Battelle Contract No. CON00011206

**Review of
EPA Hydraulic Fracturing Study Plan
EPA/600/R11/122, November 2011**

June 2012

Figure 2. EPA QMP Rev No. 1 Figure 4

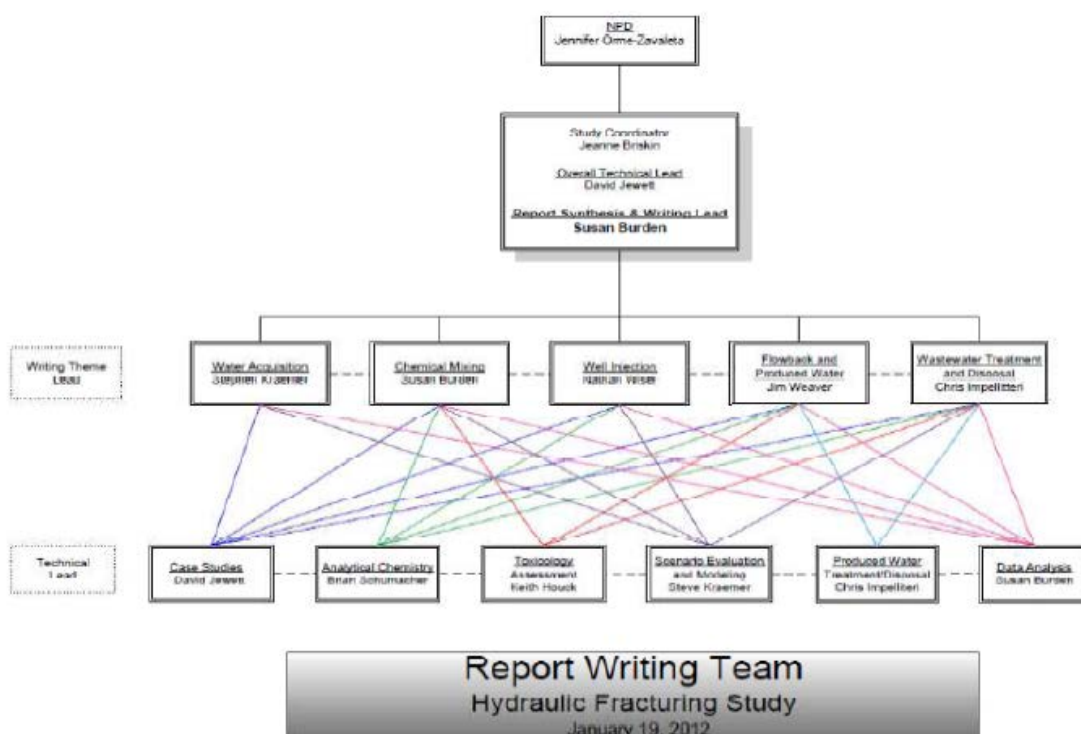
The QMP for this study does not provide guidance or requirements for the use of systematic planning. Furthermore, it does not provide sufficient guidance to ensure that all projects are: 1) conducted in a comprehensive, consistent, and coordinated manner and 2) linked to the overall program objectives defined in the study plan, even though this is specifically recognized as an essential requirement by EPA in the study plan. The QMP does not describe the coordination, roles, and communication paths for extramural participants such as consistent QA procedures and practices, nor does it delineate the communication and accountability between the Writing Theme Leads and the Technical Research Leads (see below schematic from the QMP, Figure 2).

Figure D-1. Depiction of the Hydraulic Fracturing Study Report Writing Team and Chain of Command (from Figure 4 in EPA QMP)

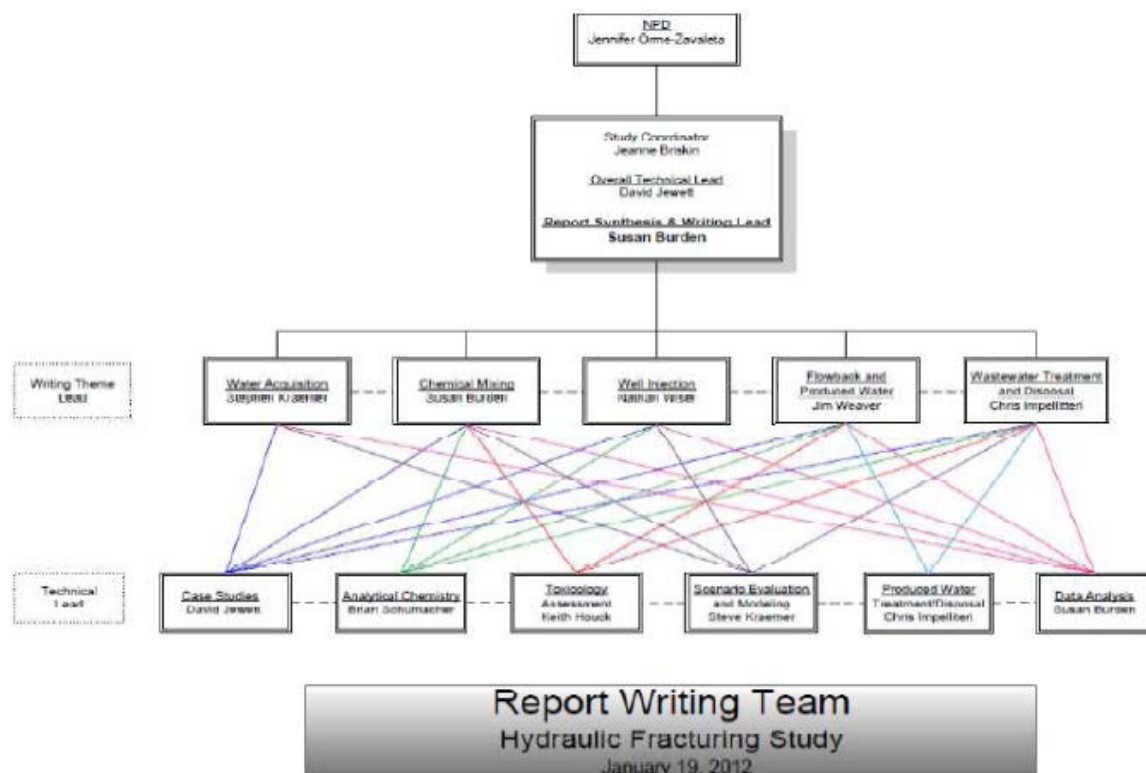
- The intended use of data and products generated for the hydraulic fracturing program is not described consistently in the QMP. The QMP states that EPA does not consider the document an official Agency dissemination of information under the Agency's Information Quality Guidelines, because it is not being used to formulate or support a regulation or guidance or to represent a final Agency decision or position. However, the QMP later states that all hydraulic fracturing projects are classified as Category I, indicating research that directly or immediately supports specific Agency rule-making, enforcement, regulatory, or policy decisions or research of significant national interest, such as tasks that might be monitored by the Administrator (Table D-1). Although neither the EPA Study Plan nor Science Advisory Board specifically mentions the Office of Management and Budget "Data Quality Act" (OMB, 2002), it appears that the EPA hydraulic fracturing program will result in reports that could disseminate influential scientific information. The QMP does not provide guidance on how study transparency will be achieved and indicates that only the 2012 and 2014 reports will receive external peer review. All other reports will receive at least an internal peer review. The internal review process and independence of reviewers is not defined.

- The QMP does not serve as the overarching quality system document that establishes policies and minimum requirements for all project activities.
